Report on Key Objections to the Proposed Gardeners' Building on the Mound at Highgate Cemetery

Planning Application Reference: 2024/5407/P

Observations on Submitted Proposals

GARDEN BUILDING AS SEEN FROM THE MAIN PATH

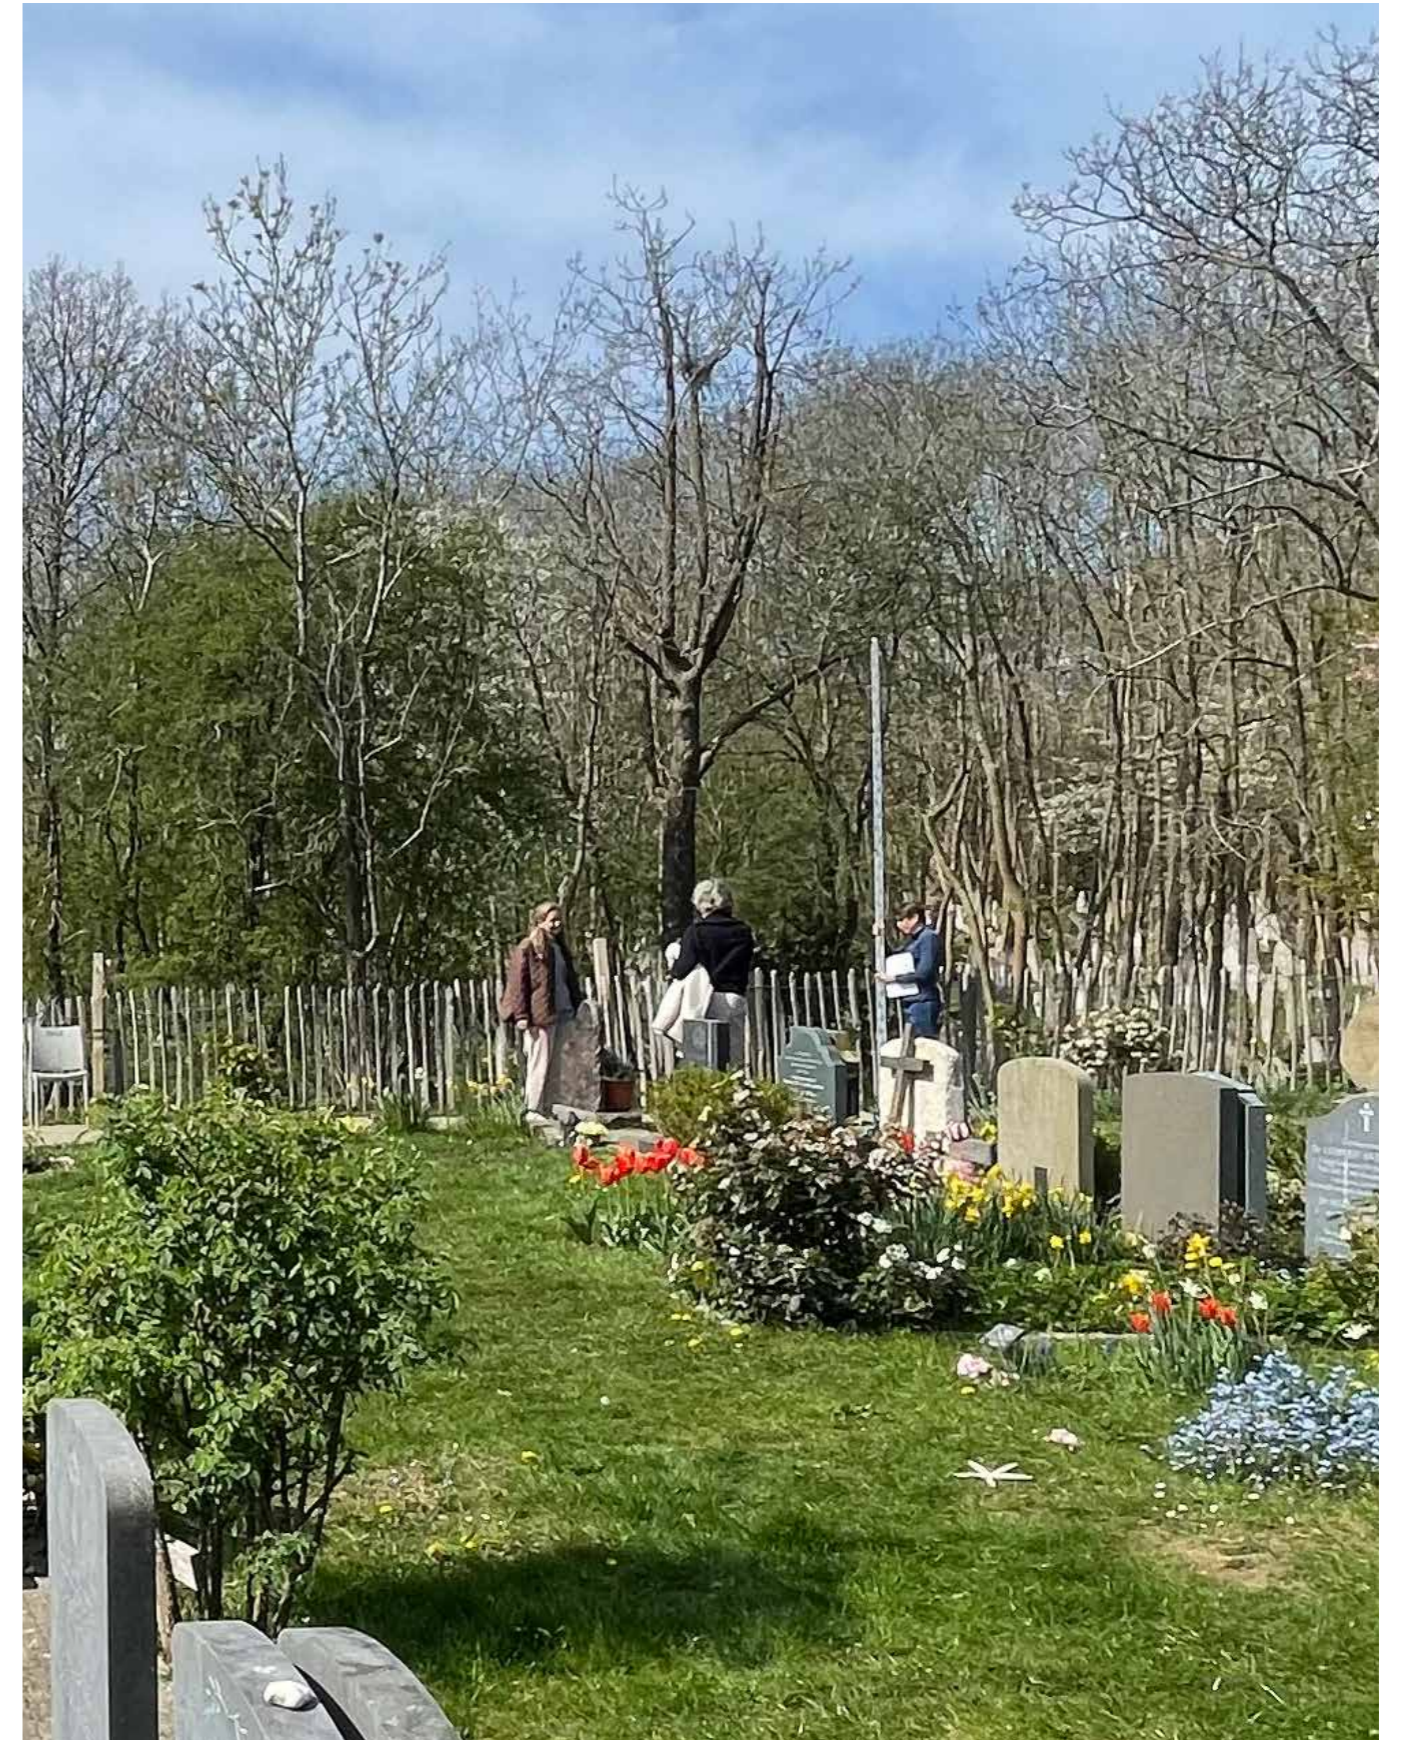
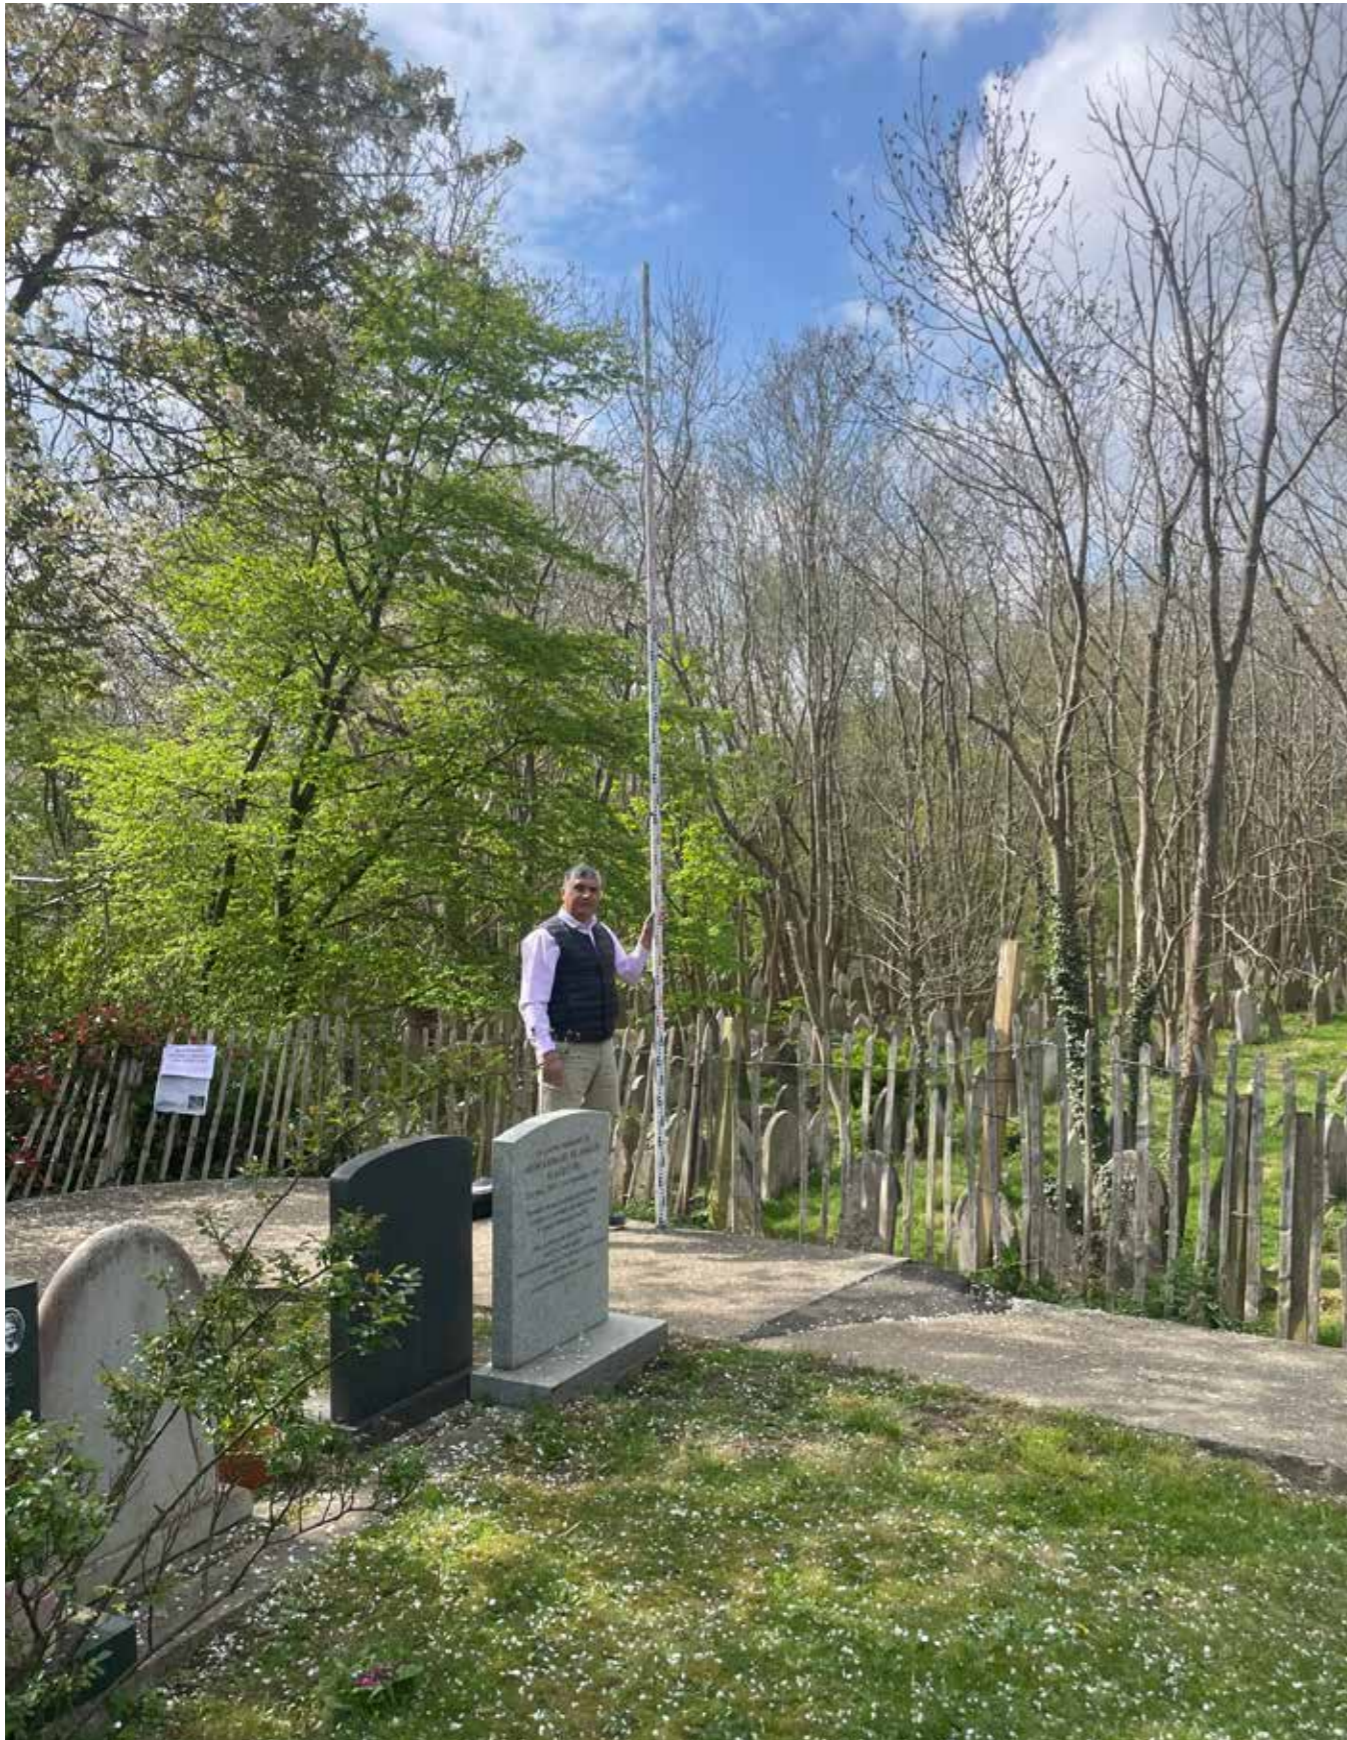
GARDEN BUILDING AS SEEN FROM THE MOUND

HEIGHT OF THE TOP SECTION OF THE GARDEN BUILDING
AT IT'S TALLEST POINT FROM THE MOUND LEVEL
COMPARED WITH THE COLONADE HEIGHT

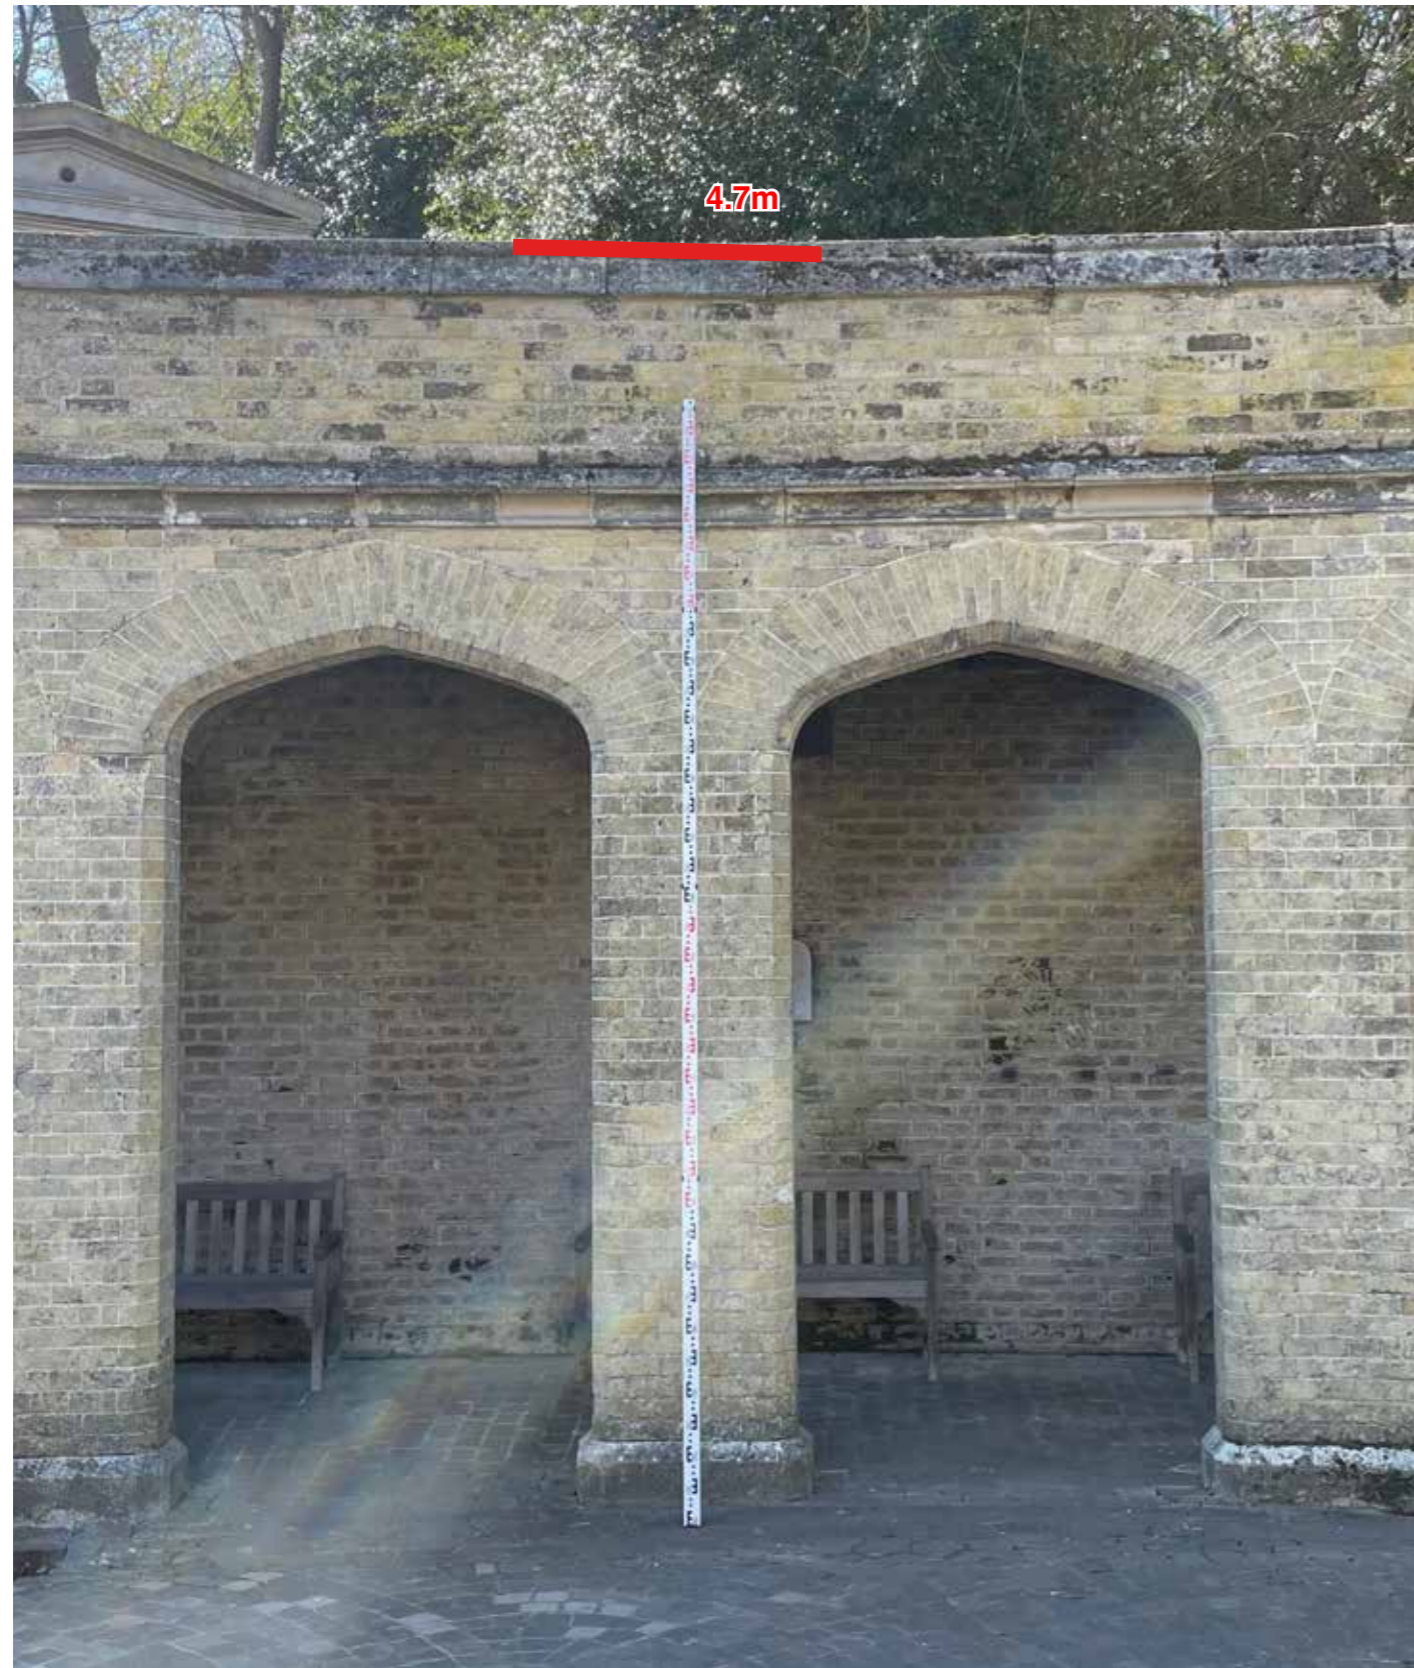
HEIGHT OF THE TOP SECTION OF THE GARDEN BUILDING
AT IT'S LOWEST POINT FROM THE MOUND LEVEL
COMPARED WITH THE COLONADE HEIGHT

PROPOSED PLAN

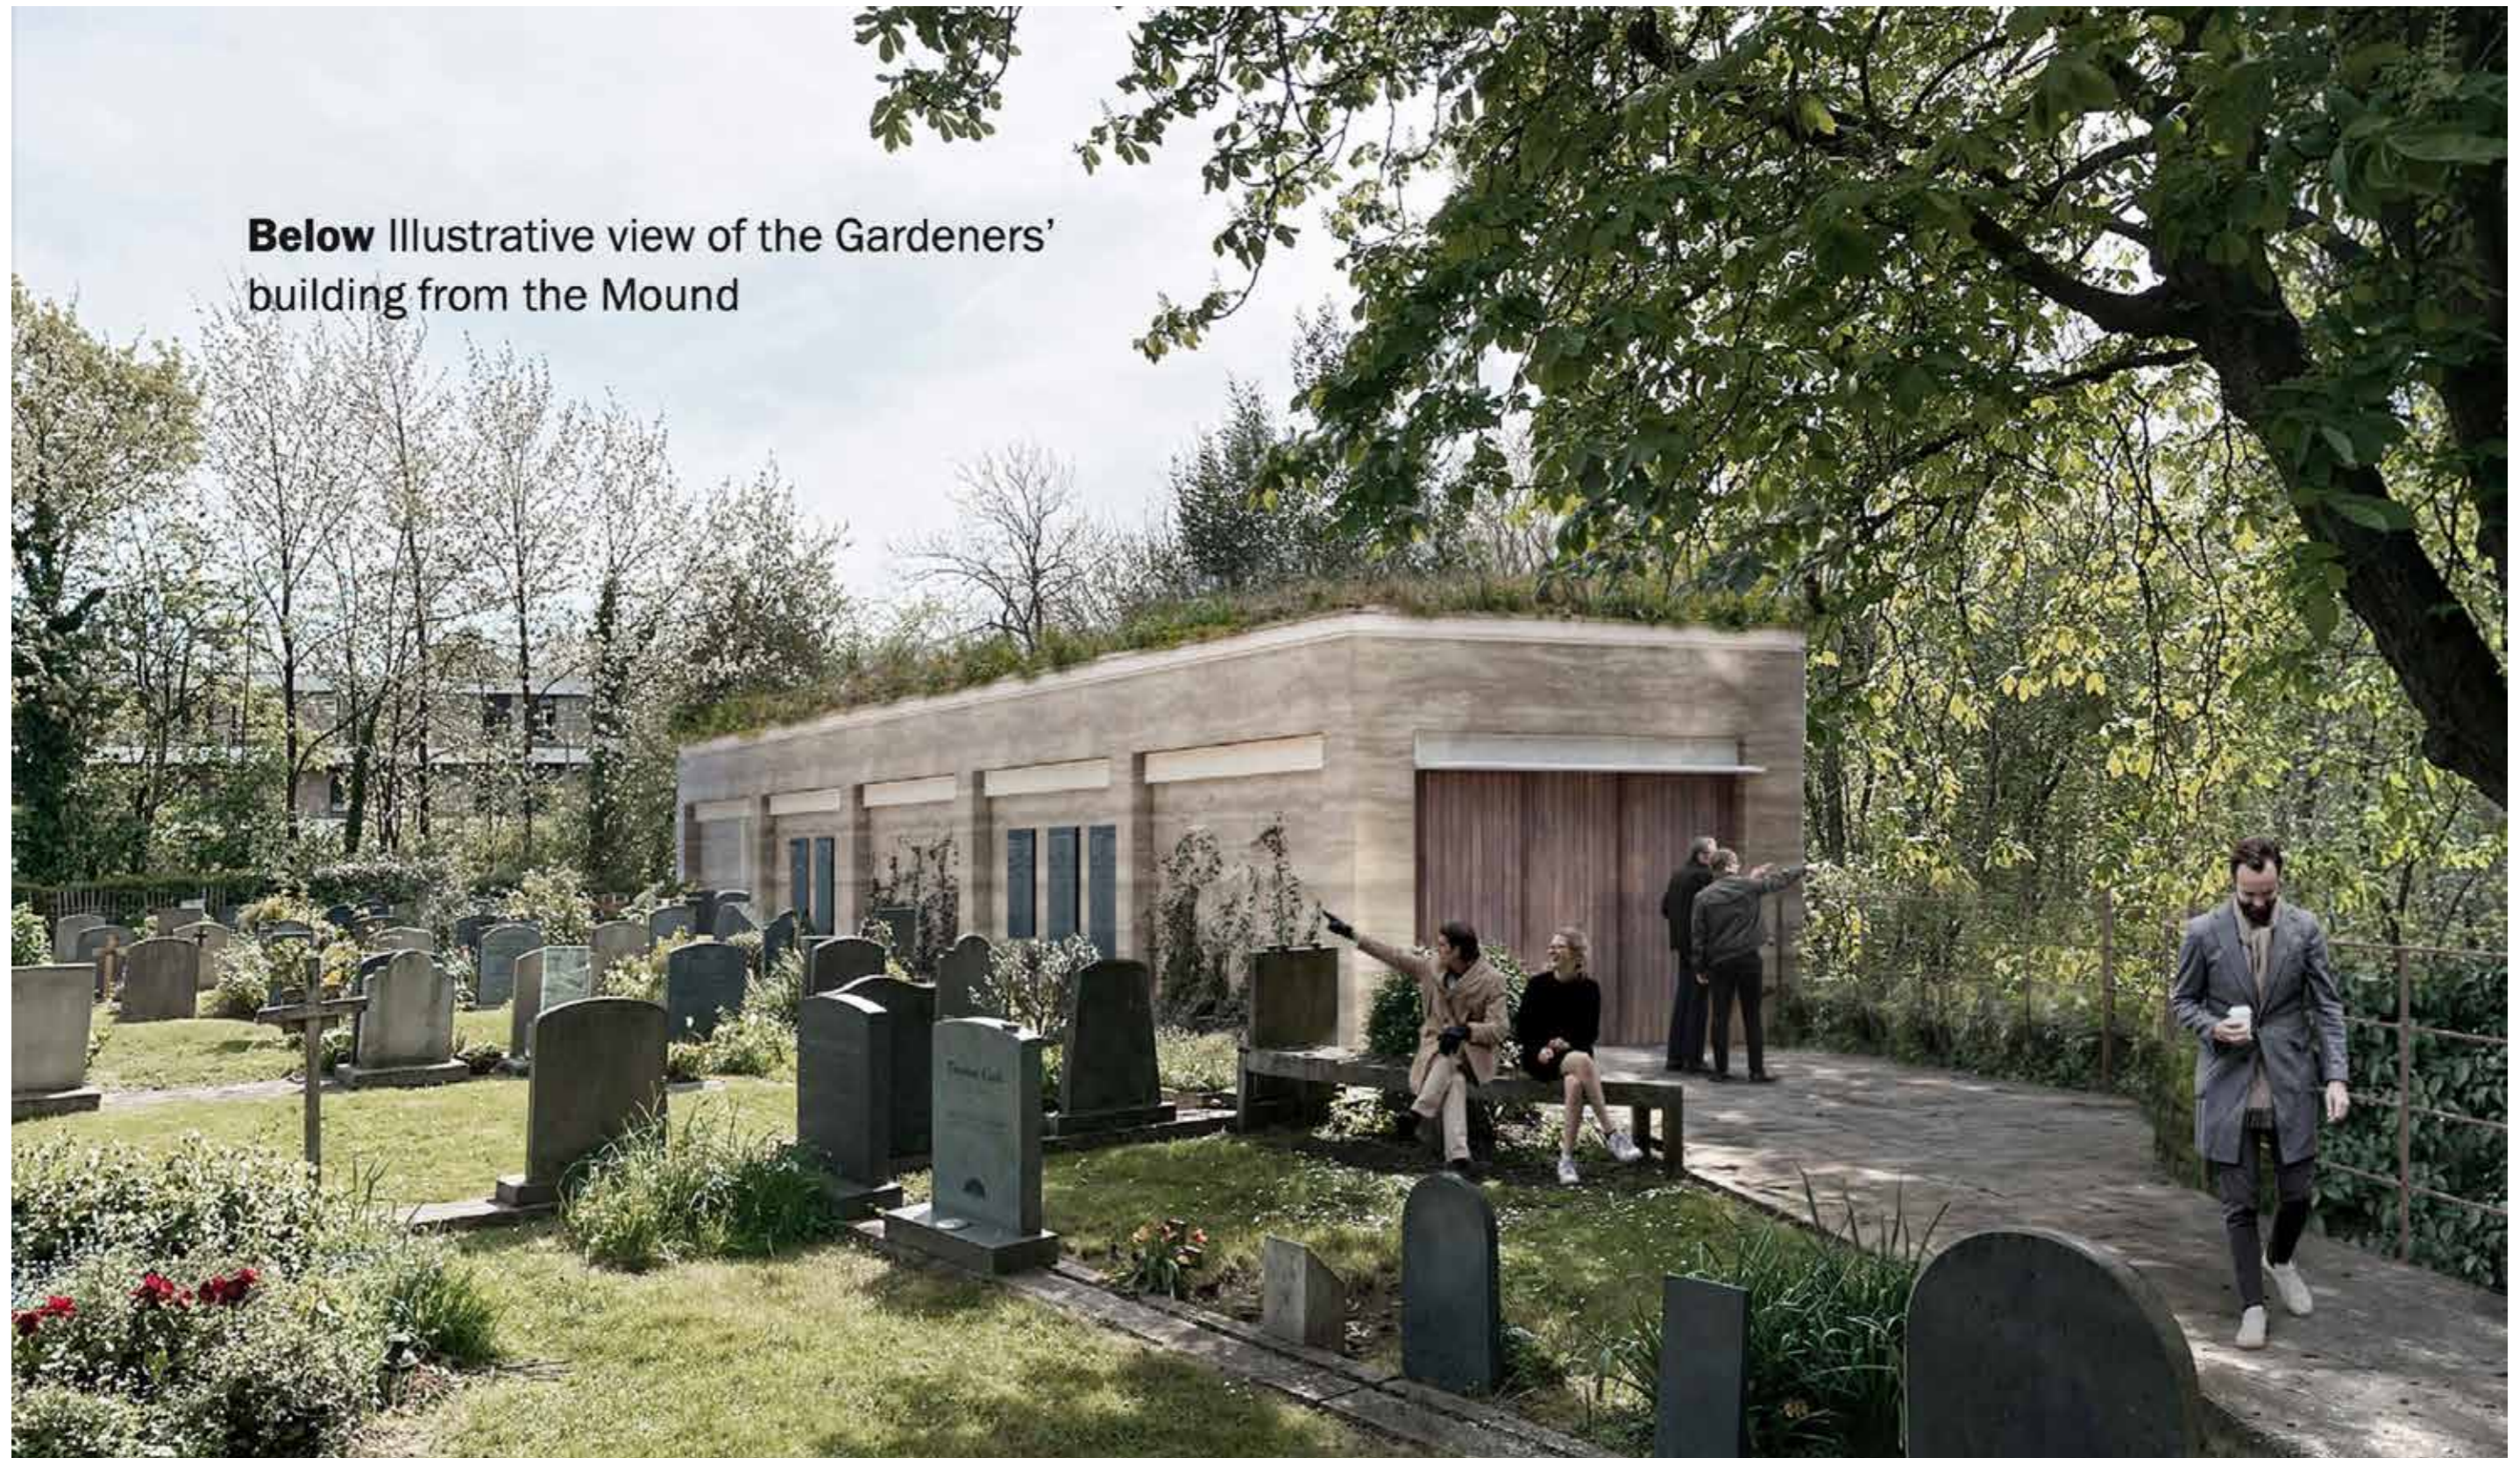
SCALE OF GARDEN BUILDING COMPARED WITH THE COLONADE. DOTTED LINE IN HIGH OF FIRST FLOOR AS SEEN FROM THE MOUND SIDE

PUBLISHED PHOTOMONTAGE IS MORE OF AN IMPRESSION. POSITIONING OF BUILDING NOT ACCURATE AND GIANT PEOPLE GIVE A FALSE IMPRESSION OF THE SCALE OF THE BUILDING
